**USACE Final Evaluator Responses and Panel's Final
BackChecks
to
Final Panel Comments
on the
Sacramento River Deep Water Ship Channel,
California Limited Reevaluation Study and
Supplemental Environmental Impact Statement IEPR**

Source: ISRI, 2011.

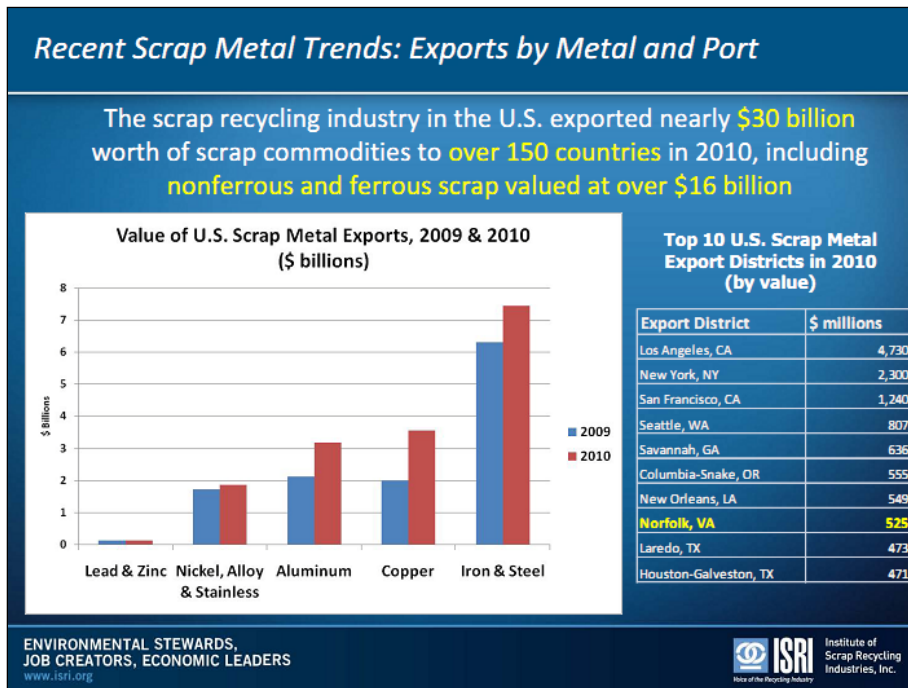
The IHS analysis (IHS, 2011, p. 46) is incorrect in stating that only two metal shredding facilities serve Northern California; in fact, there are three: Sims at RWC, Sims at Richmond, and Schnitzer at Oakland. The IHS comparison of California and Texas (p. 46) appears to be irrelevant since, according to data from the Institute of Scrap Recycling Industries (ISRI), the San Francisco Customs District exports substantially more scrap metals than Texas districts (see below).

The discussion of scrap metal export competition is therefore too narrow.

Concur: The report should improve the description and consideration of other regional facilities. We agree that the inclusion of these facilities may or may not alter the benefits because the firms located at the POWS have stated that their operating at the port is not contingent upon the deepening project.
